Submission: AIR 6000 Phase 2A/B New Air Combat Capability Facilities Project

Hunter Water Corporation (Hunter Water) has reviewed the Department of Defence's submission to the Standing Committee on Public Works (titled *Statement of Evidence to the Parliamentary Standing Committee on Public Works: Facility Requirements for the New Air Combat Capability*, dated June 2014), and wishes to make the following comments.

Annexure A – plan showing Hunter Water’s Critical Infrastructure and current registered easements

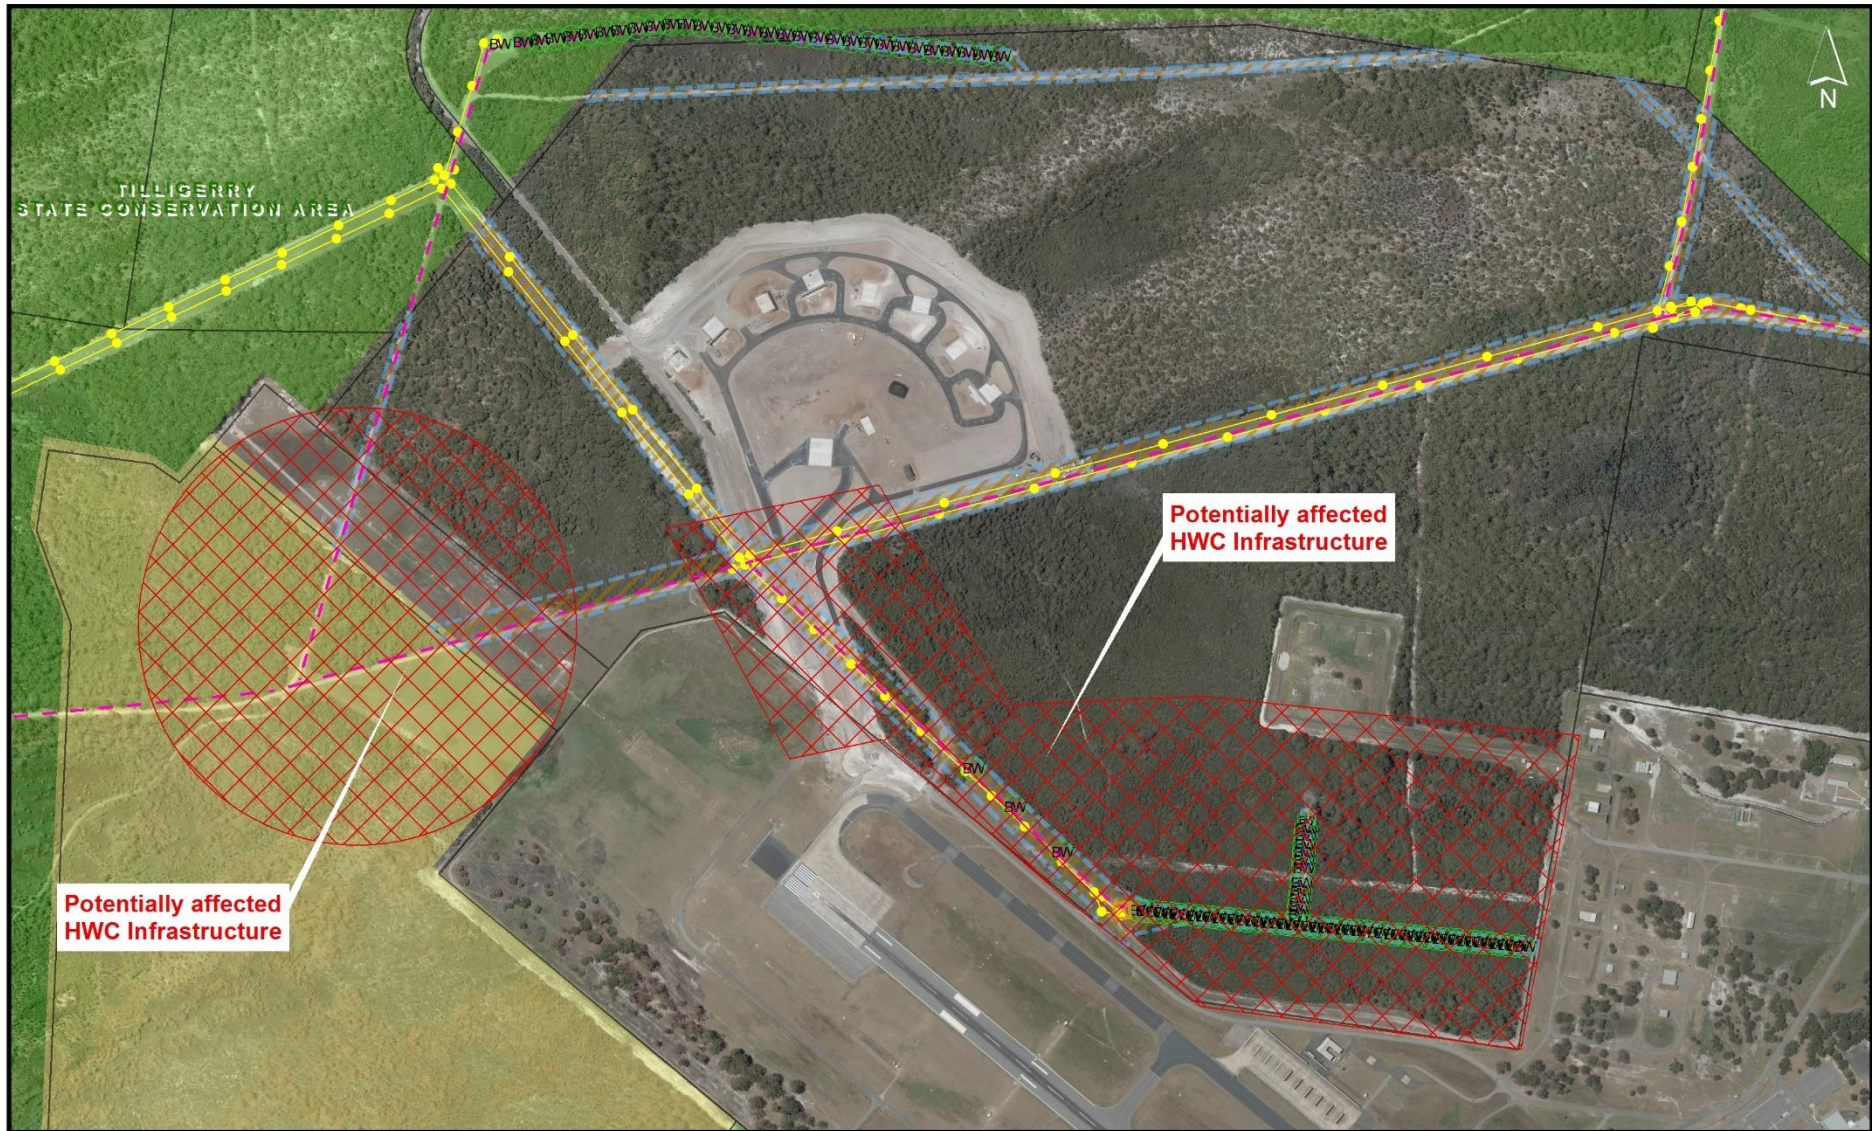
4. Hunter Water has extensive ground water extraction infrastructure within Defence land as shown on the plan at Annexure A, which is protected by registered easements and implied covenants under the *Hunter Water Act 1991* (NSW). There is currently unresolved easement issues surrounding the newly constructed ordnance facility which must be finalised prior to any further works being undertaken. See plan at Annexure B.
